DRAINAGE INFORMATION SHEET

PROJECT TITLE: Voris Construction ZONE ATLAS/DRNG. FILE #: C-23/D1d

LEGAL DESCRIPTION: Lot 652, Sandia Heights South, Unit 6

REF: DRAINAGE PLAN FOR LOT 652, UNIT 6, SANDIA HEIGHTS SOUTH (C23-D1D)
RECEIVED SPETEMBER 3, 1985

Typical wall Section

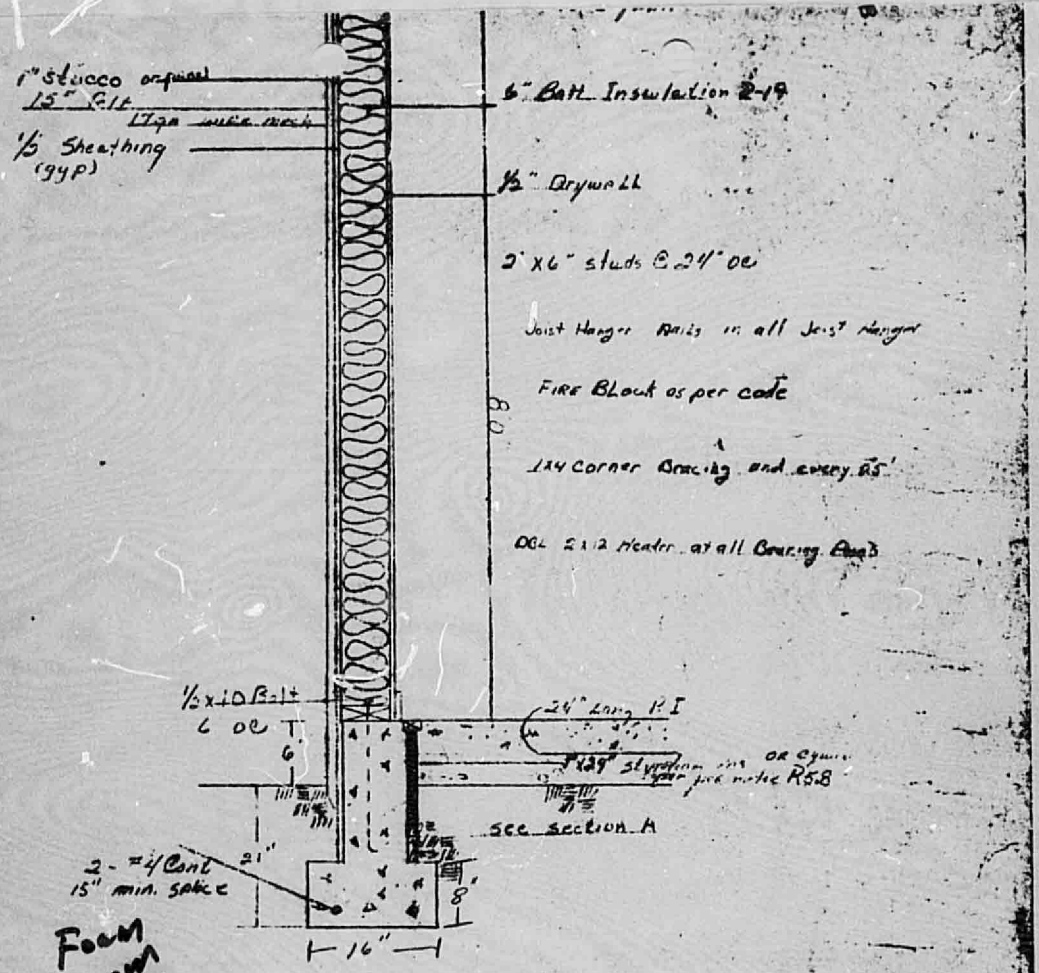
1. The floodplain has not been indicated correctly to show one foot of depth.
2. The discharge has not been calculated correctly, please correct.
3. I believe that the floodplain may encroach into the proposed structure. Please address how the house will be protected from the floodplain waters and from erosion.

2. The house, because of the proximity to the arroyo, needs to be protected from undercutting of stem wall, and patio wall (erosion) and the possibility of flows entering the structure. Vegetation is helpfull in controlling erosion, however, structural improvements need to be made.

The house is built on an UBC approved footing and stem of which there is an attached drawing.

3. The floodplain does not encroach into the proposed structure. As a precaution to erosion the contractor has agreed to submit a cross section of the actual footing w/ elevations, and a proposed plan for future landscaping to prevent such erosion. See enclosures.

2. The house, because of the proximity to the arroyo, now shows a constructed footing along the northside of the house which varies 6 to 12 feet away from the wall of the house. The new footing is a minimum of one foot below the footing and stem of the existing house.

CROSS SECTION OF ARROYO

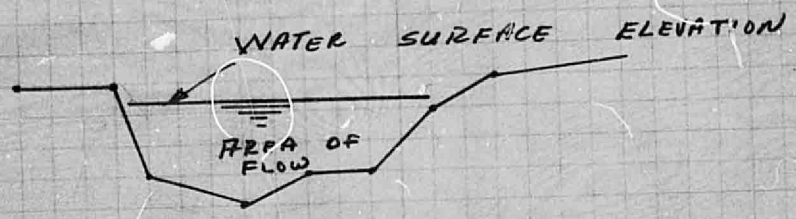
3. The velocity calculations were not done correctly. Please see my attachment for information in calculating velocity.

ELEV. (FT)
6167
66
65
64
63
62
61
60
59
58
57
6156
0
70
80
90
100
110
120
130
140
150
160
170
180
190
200
210
220
230
240
250
DISTANCE STARTING AT WEST ℄ (FT)
GARAGE F.F. 63.5
HOUSE F.F. 63.9
57¼
BOTTOM OF FOOTING
AD = 1 ft.
PROFILE OF ARROYO
1-22-86

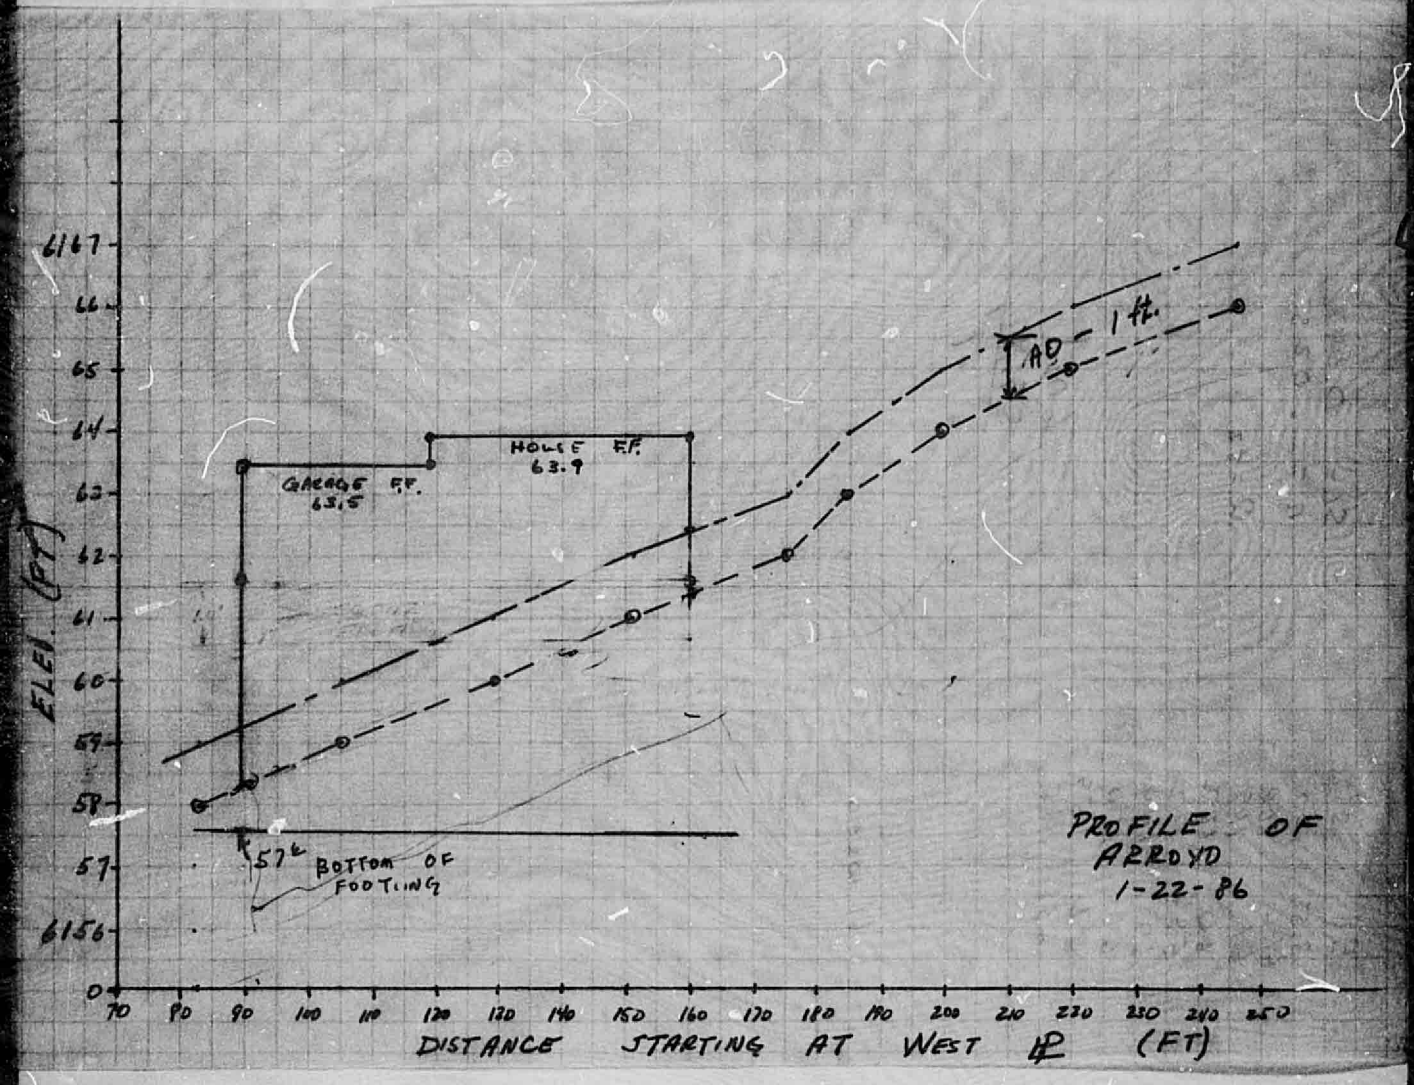
1. Attached to this letter is a profile of the arroyo. If the arroyo were to scour, the 1 foot footing does not appear to protect the foundation. Unless you calculate a different scour depth, please use three (3) foot of depth below the arroyo flow line.

2. Also, in the attachments is an area where the channel may overflow. Please address what protection will be necessary for this area.
